MITSUBISHI HEAVY INDUSTRIES MARINE MACHINERY & ENGINE CO., LTD.

Subject : Tightening Standard of Bolt for Fuel Oil Inlet/Outlet Branch Pipe	Application	Mitsubishi-UEC Diesel Engine
	Type	UEC (Refer to table)
	No.	MSI-1559E Rev.5
At early opportunity

O-ring type

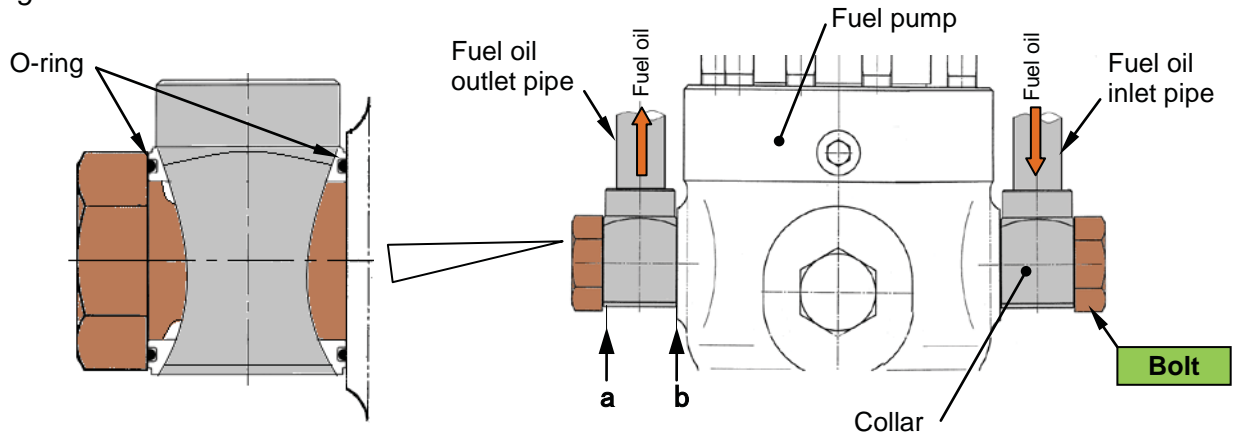
It has been reported from some vessels in service that bolts for fuel oil inlet/outlet branch pipe were cracked. The crack seemed to be caused by over tightening of a bolt. Therefore, the tightening standard of the bolt is shown in page 2/E. Please be careful about tightening the bolts when fitted the inlet/outlet branch pipe on the fuel pump.

Before tightening the bolt, thread size of bolt shall be confirmed. When tightening the bolt for fuel oil inlet/outlet branch pipe, make sure that there is no gap between the bolt and collar(a) and between collar and fuel pump surface(b). Then, tighten the bolt with above *tightening angle*.

Thread size of bolt	M26 x 1.5	Tightening torque	* 68Nm (6.9kgf·m)	Note : *Tightening torque values are for reference.
		Tightening angle	6°	
	M45 x 3	Tightening torque	* 200Nm (20.4kgf·m)	
		Tightening angle	5°	
	M56 x 2	Tightening torque	* 370Nm (37.7kgf·m)	
		Tightening angle	7°
